COMAL COUNTY

Permit of Authorization to Construct an On-Site Sewage Facility Permit Valid For One Year From Date Issued

Permit Number: 116336
Issued This Date: 12/20/2024
This permit is hereby given to: John M Golden

145 FM 2673
CANYON LAKE, TX 78133

GOLDEN JOHN M
145 FM 2673
CANYON LAKE, TX 78133
A-417 SUR-323 G C MCWHORTER
ACRES 2.942
COMAL COUNTY/2.942 ACRES

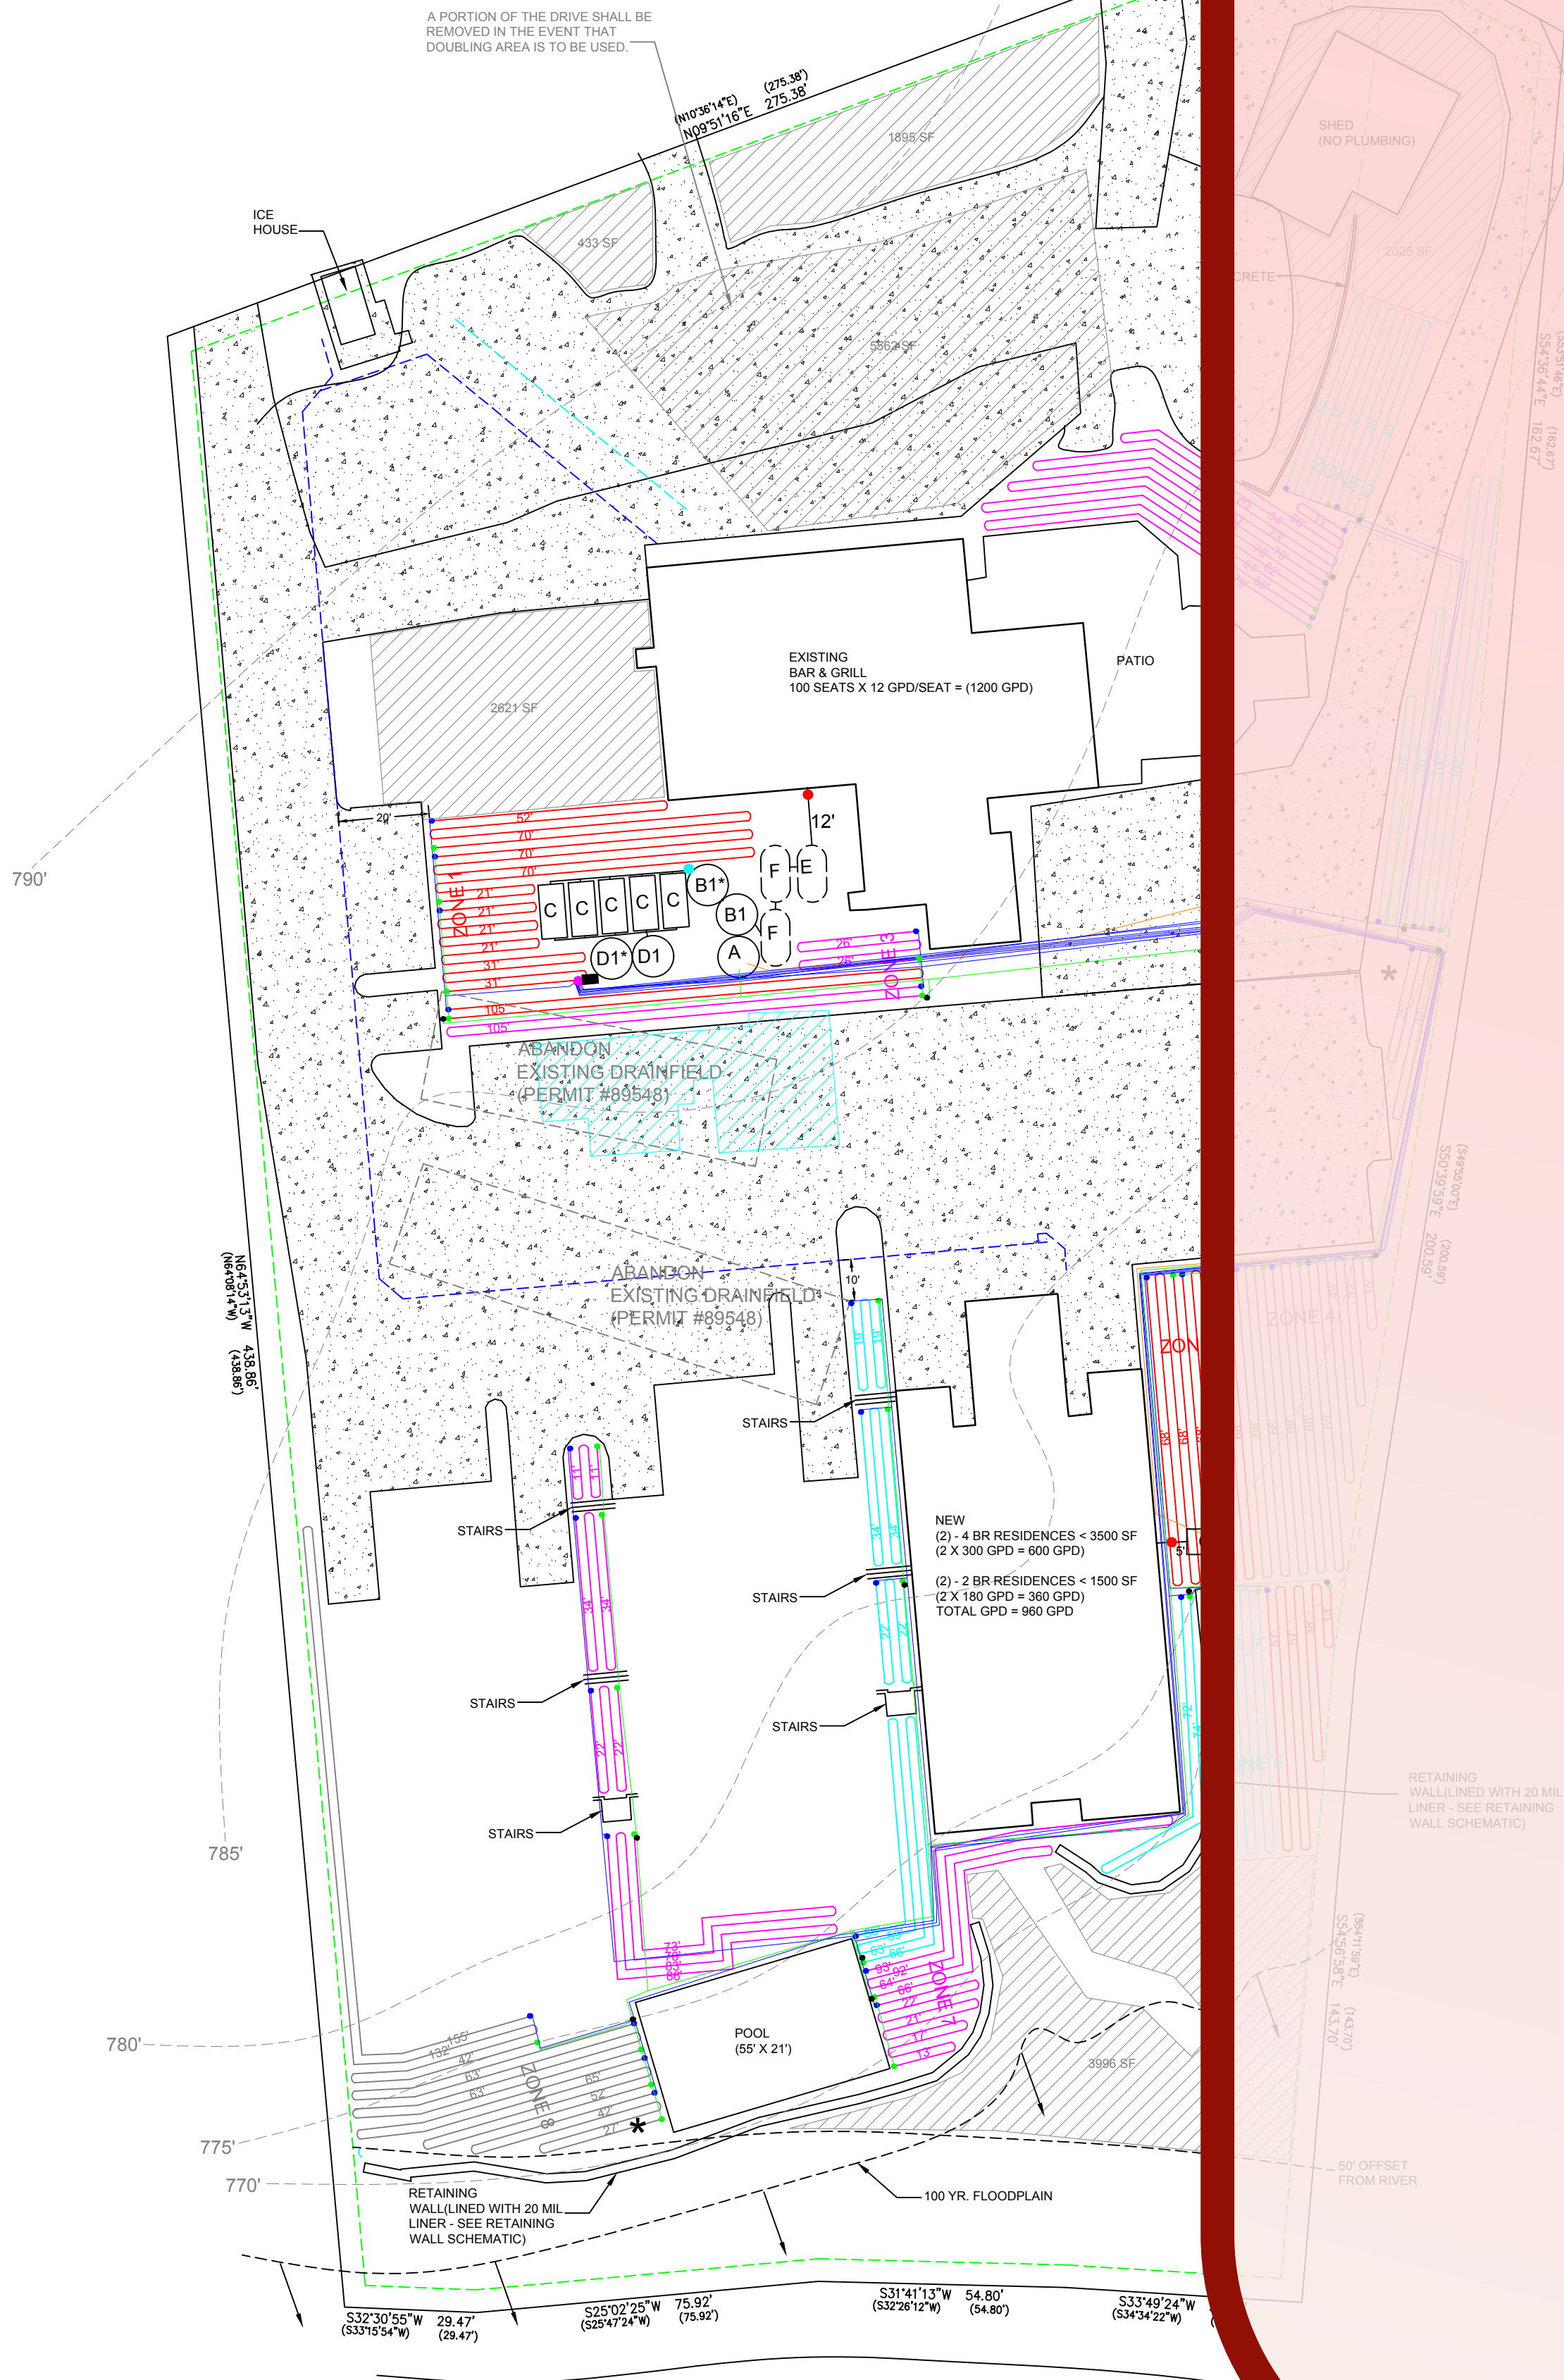
- The aerobic treatment units consist of five treatment plants. The dosing to the treatment plants is through an indexing valve, which provides no ability for the maintenance provider to control dose rates to treatment units or allow controlling flow to given plants. An alternative approach to dosing the plants (orifices or weir box) would allow controlling of the doses to the treatment plants.

- A comprehensive drainage plan should be developed to move stormwater from the buildings. The drip field loading rate is 2.5 times the landscape water needs. The fall should be diverse drip field maintenance for effluent management. TAC 285.4(c)

A 2" ball valve will now be installed on the line going into each aerobic treatment unit, which will be adjusted to provide equal flow to each aerobic treatment unit - see site plan and spec sheet.

Drainfield shall be crowned slightly to show inwards - see site plan
